WB11-54

AIR SPRING MEMBER REPLACEMENT 9700 (B13R)

DESCRIPTION

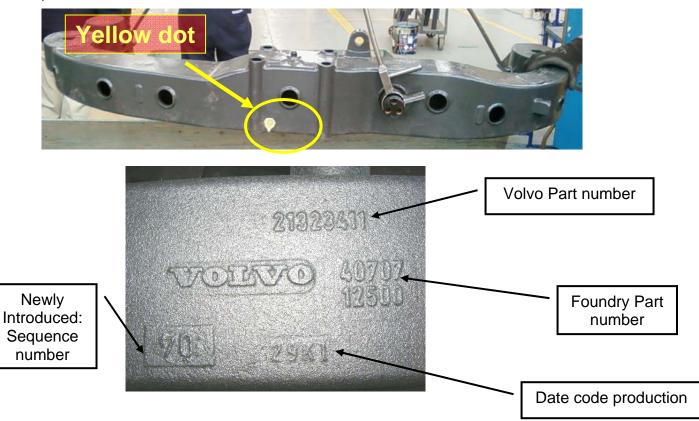
On the vehicles affected by this bulletin, the left-hand and right-hand side air spring members are not compliant and have to be replaced as soon as possible and before the expiration of this bulletin. The new members can be recognised by the yellow dot they have and/or a sequence number of the casting, see pictures below.
